Delmore Fast Track Application

Appendix 8: A06 (Geotechnical) to Response to Comments letter

Re: Geotechnical Response Memorandum

Project		240065 - Russell Road, Wainui - Stage 2	
	Group	Section Z - Proposed GL	Scenario	Normal (Measured GW)
	Drawn By	LKB	Company	Riley Consultants Ltd
	Date	10/12/2024	File Name	Section Z.sldm
	SLIDEINTERPRET 9.040

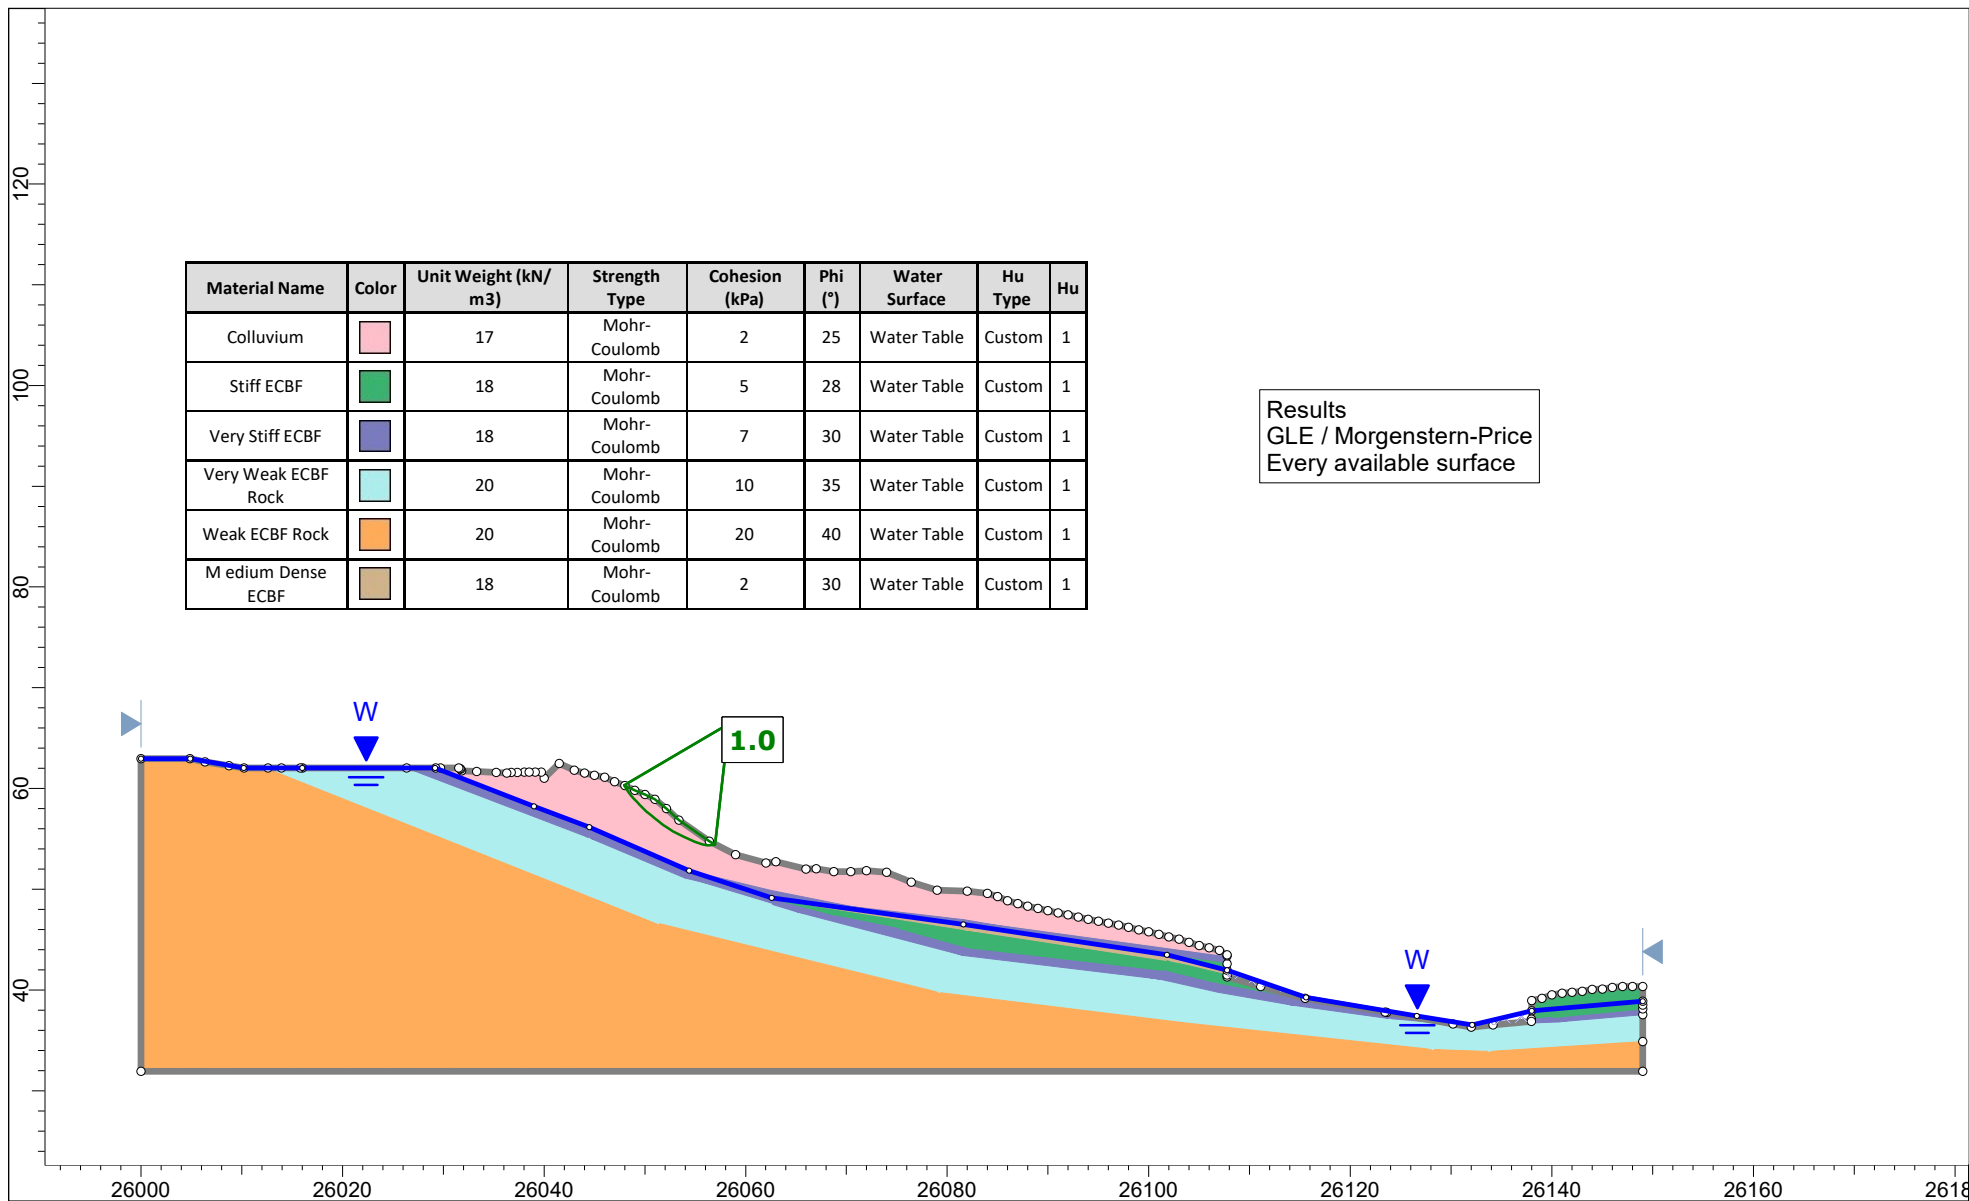
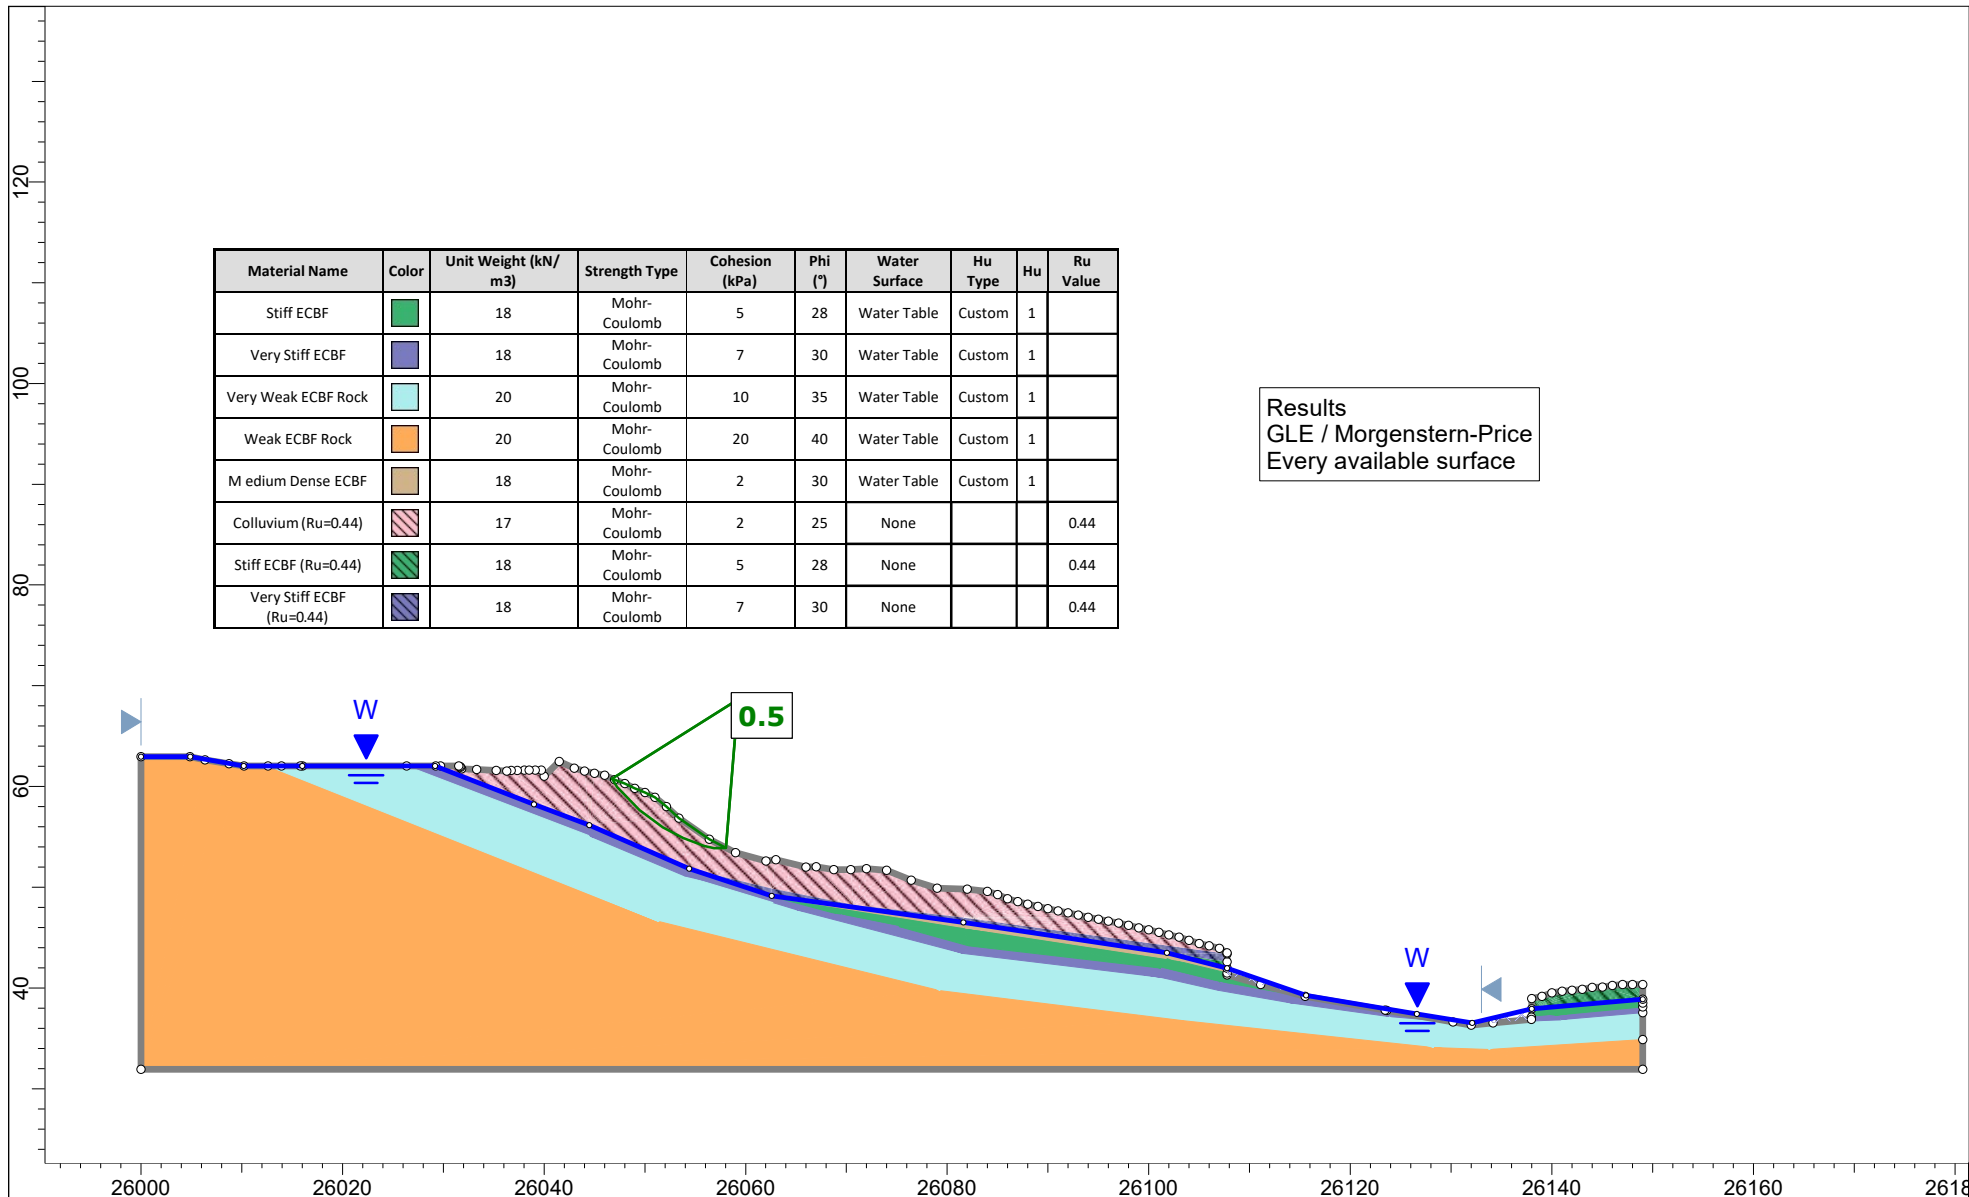
Slope stability output For Section Z, no surcharge load appears to have been considered in the analysis. Suggest that this decision be clarified or the model revised.	Stability analysis outputs for this cross-section with the surcharge added are attached to this memo. No notable change to the output results. Recommendations in the GIR remain appropriate.	Accepted and closed.	Resolved and stability analysis is included in Attachment A for the Panel's reference.

SLIDEINTERPRET 9.040	<i>Project</i> 240065 - Russell Road, Wainui - Stage 2	
	<i>Group</i> Section AC - Proposed GL	<i>Scenario</i> Extreme (Worst Credible GW)
	<i>Drawn By</i> RS	<i>Company</i> Riley Consultants Ltd
	<i>Date</i> 10/12/2024	<i>File Name</i> Section AC.slmd

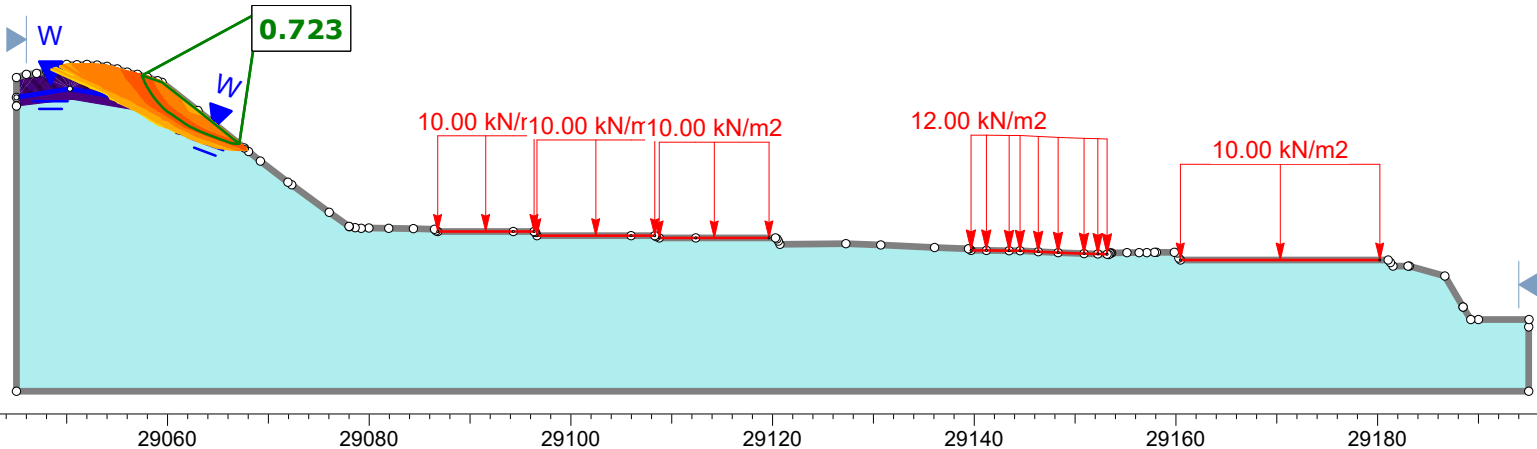
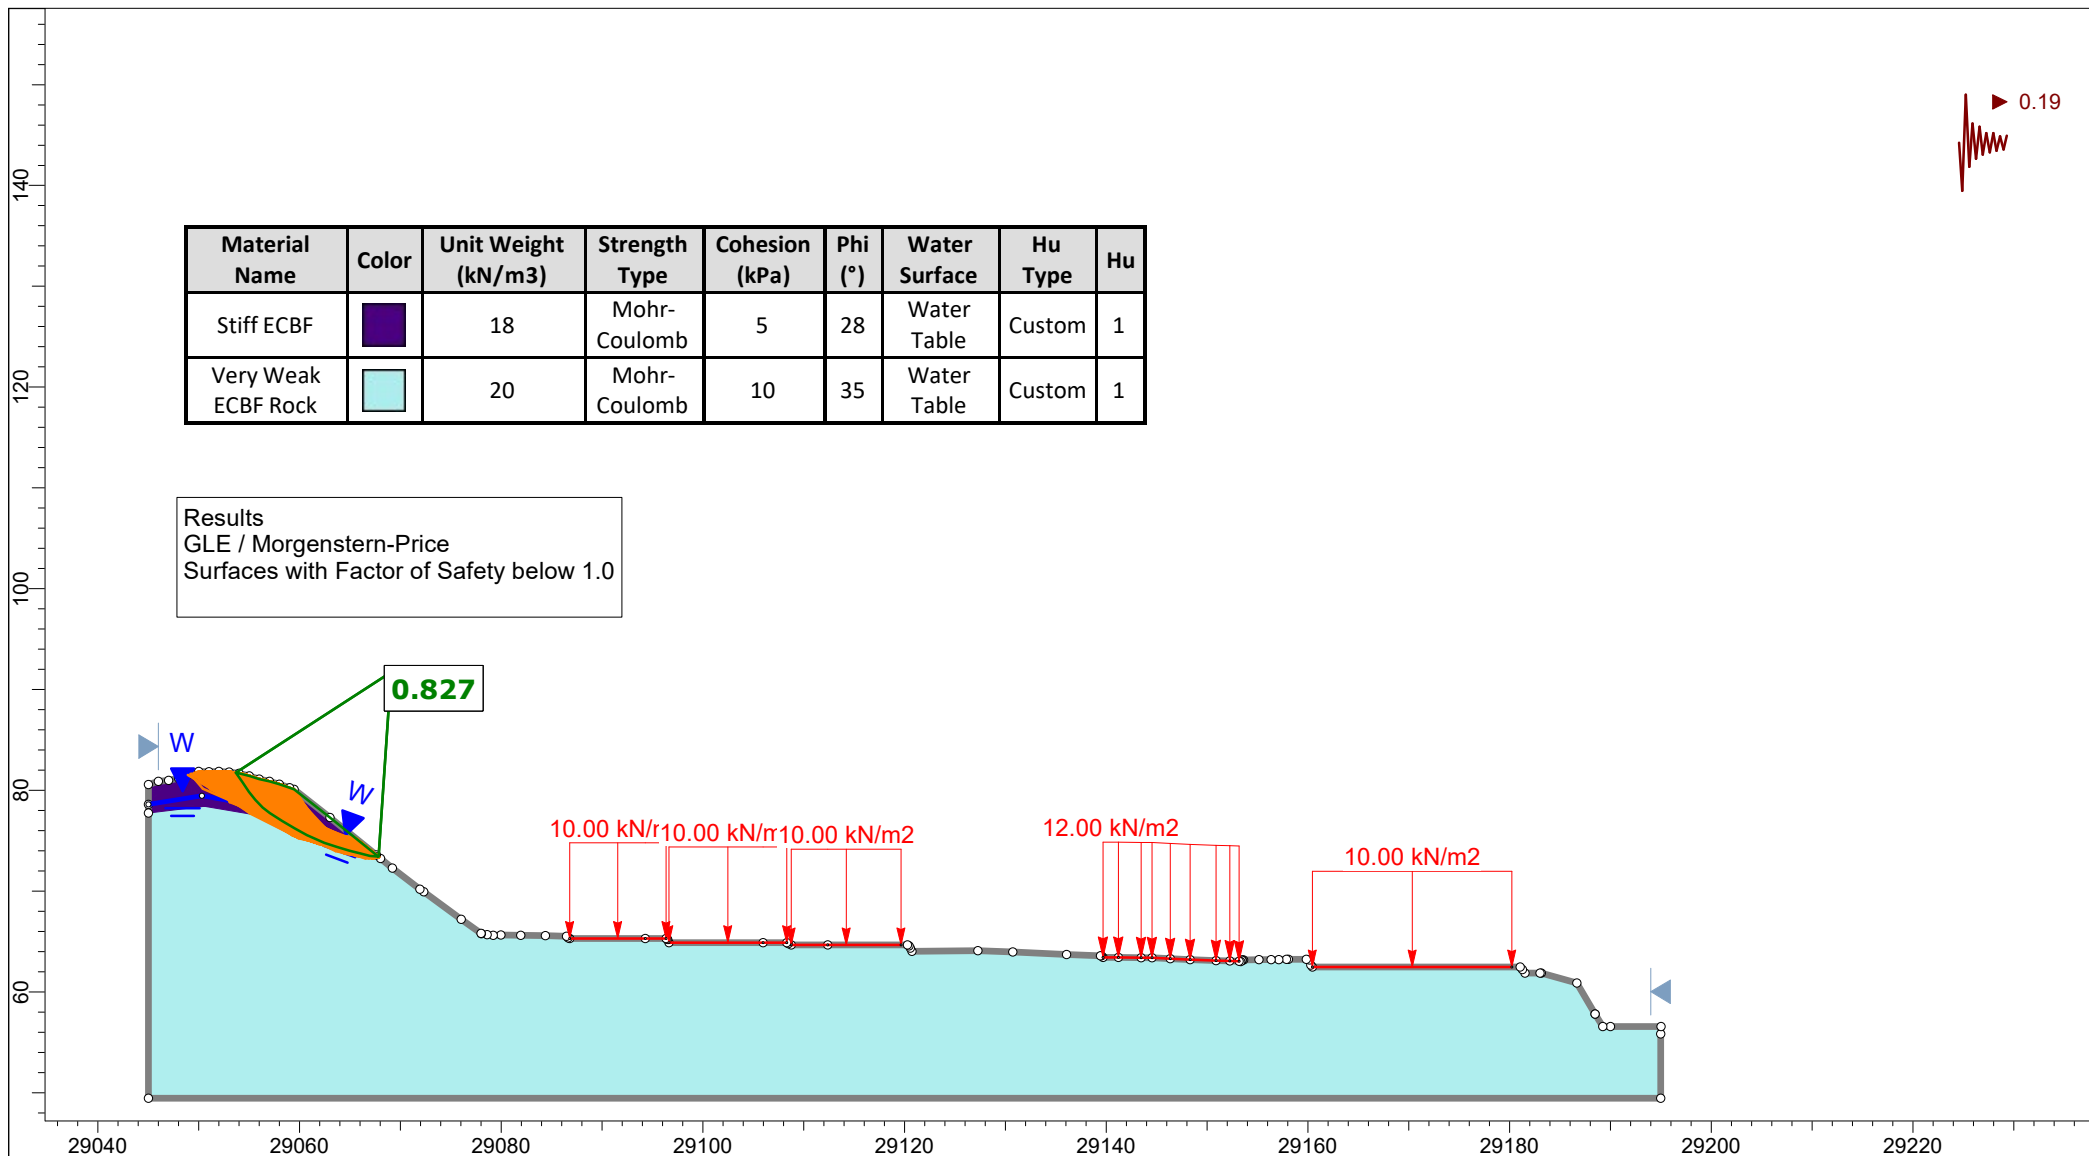
Slope stability output The output page for Section AC is not legible for regulatory review. Suggest that a clearer output be provided.	Stability analysis outputs for this cross-section have been re-outputted to be clear and are attached to this memo. No change to the calculated FoS. Recommendations in the GIR remain appropriate.	Accepted and closed.	Resolved and stability analysis is included in Attachment A for the Panel's reference.
Remediation Plan It is noted that the remediation plan indicates the use of a reinforced earth batter (REB) to retain a cut slope. It appears that the REB may have been erroneously extended from Section AD where filling is proposed. A more practicable option in this instance may be appropriate. Suggest that confirmation that the notation on the remediation plan is correct or a revision provided to reflect intended works.	The remediation plan has been updated and is attached to this memo. The subject portion where cuts are proposed to be formed has been changed to soil nails (consistent with the nearby Section AC). The extent of each type of stability enhancement measure will need to be confirmed during detailed the design. See updated Riley sketch SK143 attached.	Accepted and closed.	Resolved and the remediation plan is included in Attachment B for the Panel's reference.
